SCOPE OF WORK

FORD KALBFELD PROFESSIONAL LANDSCAPE DESIGNER

EXHIBIT 5

SINGLE FAMILY RESIDENCE 124 BARDEN HILL DRIVE, LOS BATOS, 07

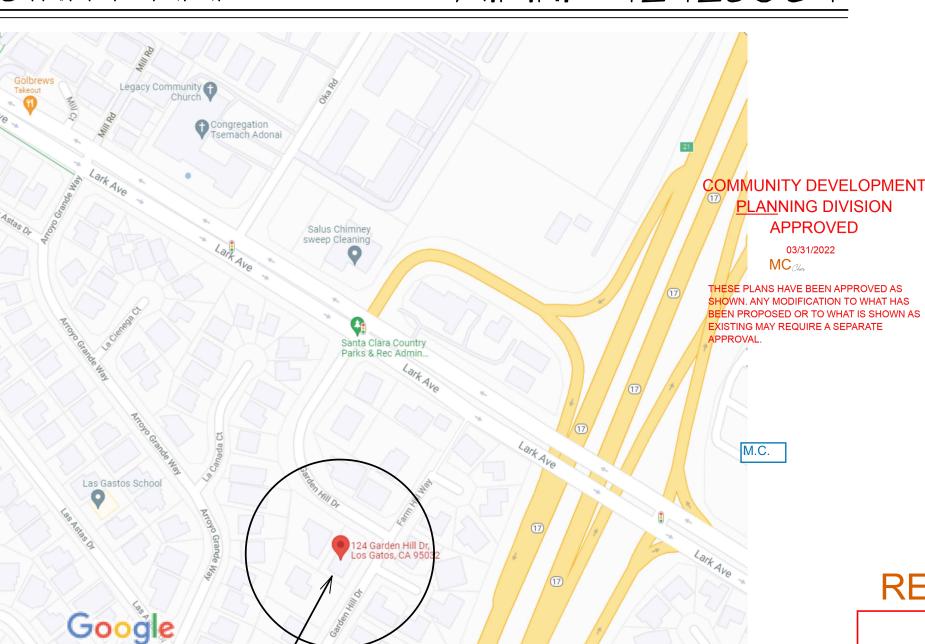
* Air Admittance Valve not Permitted

Section 714.2

*Island Loop Vent not Permitted line of street

securely supported. CPC Section 906.4

*Vent Pipe for the outdoor sink installation shall extend not

* Provide a cover for the outdoor sink, which is required by

the Town Building Division to allow the sink that is open to

*The Sanitary Sewer Drainage System of the new outdoor

dwelling with an independent connection with the public or

kitchen must be separate and independent from the main

private sanitary sewer system downstream from the main

house sewer line to the street. CPC Section 311.0

the sky to discharge into the sanitary sewer system per CPC

less than 10 feet above the surrounding ground and shall be
